Service Bulletin
No. : MZ01-012
Date: November 29, 2006

Model: SA-1/SA-14

**Subject:**   Improvement for TOC read error, etc.

figure 2

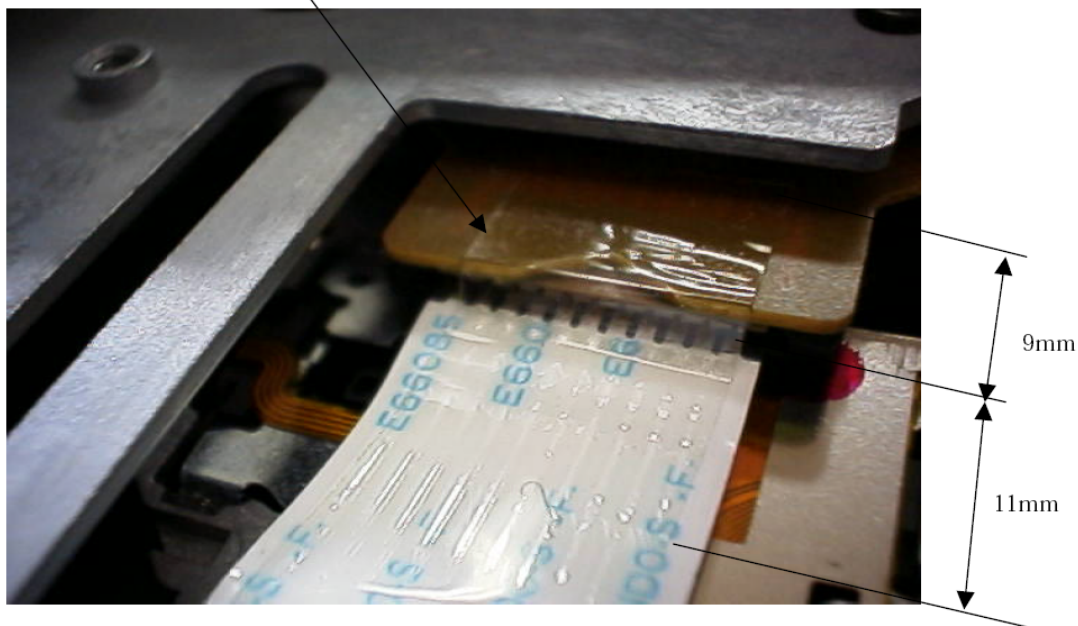
Solution: 1) <u>Exchange a motor wire.</u>   Exchange the 100 micron motor wire (flex cable) for a 35 micron type. Before the motor wire (35 micron) can be used it must be formed (see "figure 1" for details). Insert a DISC (ex. BURN-IN TEST DISC) in the unit and play the outermost track (ex. Tr.20). While playing the outermost track, pull AC plug and power the player off. Remove the top cover, and SACD mechanism. Remove the mechanism cover (position number: 322) from SACD mechanism.   Remove the test disc from SACD mechanism.   Apply 20 mm of adhesive tape to the wire socket and wire, at the SACD mechanism side. Do this after a motor wire has been replaced (refer to "figure 2") . Adhesive tape should use the surely specified above-mentioned thing

Adhesive tape(parts number: *3M-NO859T),   length=20mm
